HORSHAM DISTRICT COUNCIL CONSULTATION

TO:	Horsham District Council – Planning Dept
LOCATION:	Former Novartis Site Parsonage Road Horsham West Sussex
DESCRIPTION:	Residential development comprising approximately 206 dwellings, including the conversion of 'Building 3' and demolition of 'Building 36'. Vehicular access taken from Wimblehurst Road. Car and cycle parking, landscaping and open space and associated works. The replacement of the existing cedar trees at the site.
REFERENCE:	DC/25/0629
RECOMMENDATION:	More Information / Modification
SUMMARY OF COMMENTS & RECOMMENDATION: <p>Please seek advice from the tree officer in regard to the encroachment of brick walls and storage provision within root protection areas (RPAs) of the existing trees alongside Parsonage Rd and the impact of proposals on their long-term retention. In addition, plans should be updated to show consistency across the scheme.</p> <p>A land budget plan is also requested to demonstrate compliance with the open space requirements. It may make sense to combine open space requirements with the Muse site in order to address open space provision holistically across the two.</p>

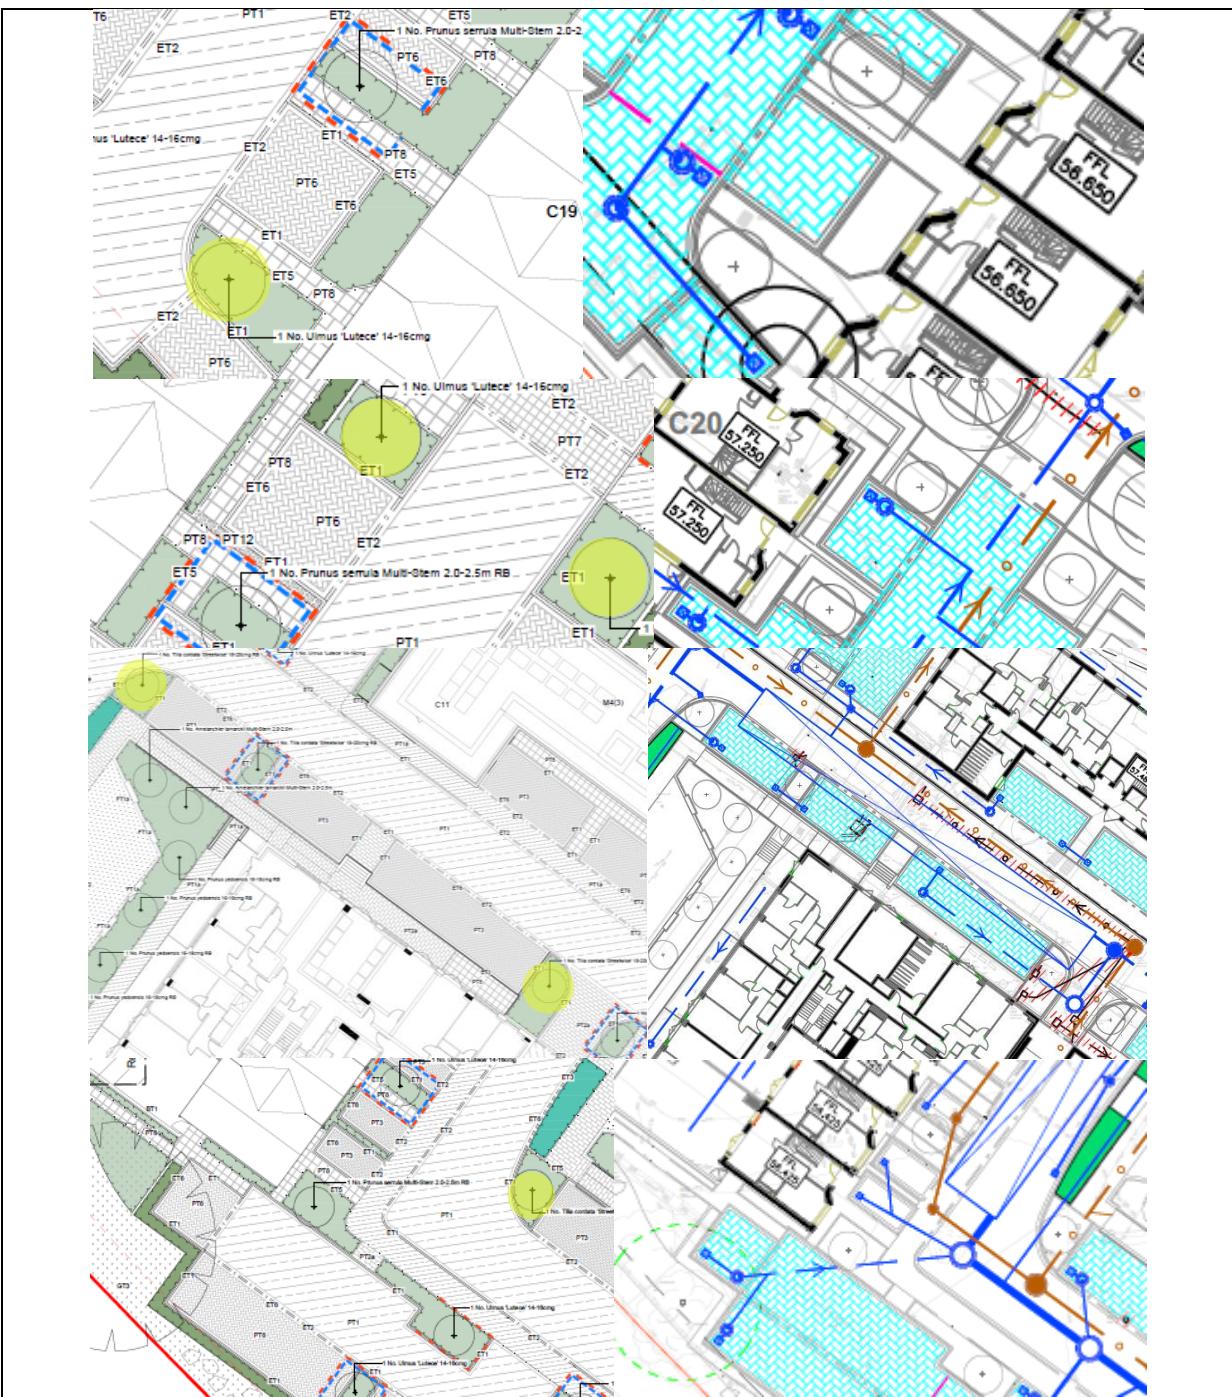
15. While the locations of root barriers are welcomed, we note that some appear to be absent and should be added to the LGA for completeness. Please see examples highlighted in yellow, below, where trees are in proximity to service runs.
